NOTICE OF VIOLATION

INSPECTION REPORT

Electrical Corporation:	Pacific Gas & Electric Company
Report Number:	CAD_PGE_KSF_20250408_1326
Inspector:	Keyshawn Ford
WMP Year Inspected:	2024
Quarterly Data Report (QDR) Referenced:	Quarter 4 (Q4)
Inspection Selection:	Energy Safety viewed the contents of the Q4 QDR and performed an analysis that resulted in the selection of the WMP initiatives and locations referenced in this report.
Relevant WMP Initiative(s):	8.1.2.10.5 - Non-Exempt Expulsion Fuses
Date of inspection:	April 8, 2025
City and/or County of Inspection:	Los Gatos, Santa Clara County
Inspection Purpose:	Assess the accuracy of PG&E's QDR data, completeness of its work, compliance with WMP requirements, and compliance with its protocols.

Violation 1

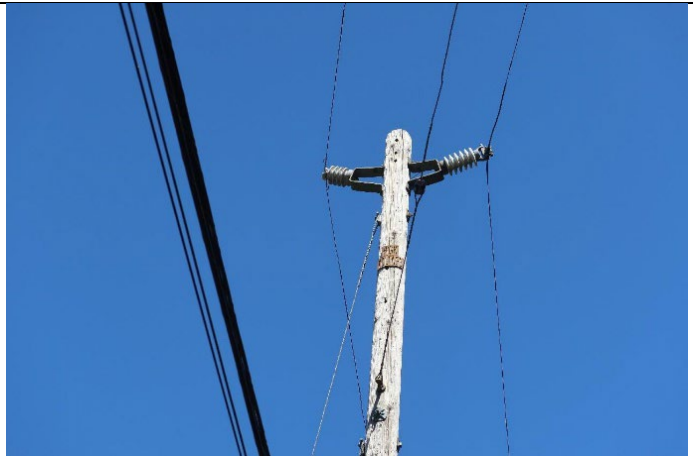
On Pole ID GT 105595, Grid Hardening ID 31661650 at 94 Hernandez Ave, Los Gatos, CA, 95030, 37.22828560877868, -121.99130148338494, the inspector observed no exempt fuses installed on the pole. The inspector's observation is documented in Violation 1 photographs, which are attached to this report. Photo numbers Item1IA1Img1 and Item1IA1Img2 depict a distribution pole with no exempt fuses present.

1. Exempt fuses were not observed on the pole.
2. Data provided by PG&E indicated that exempt fuses were installed at this pole.
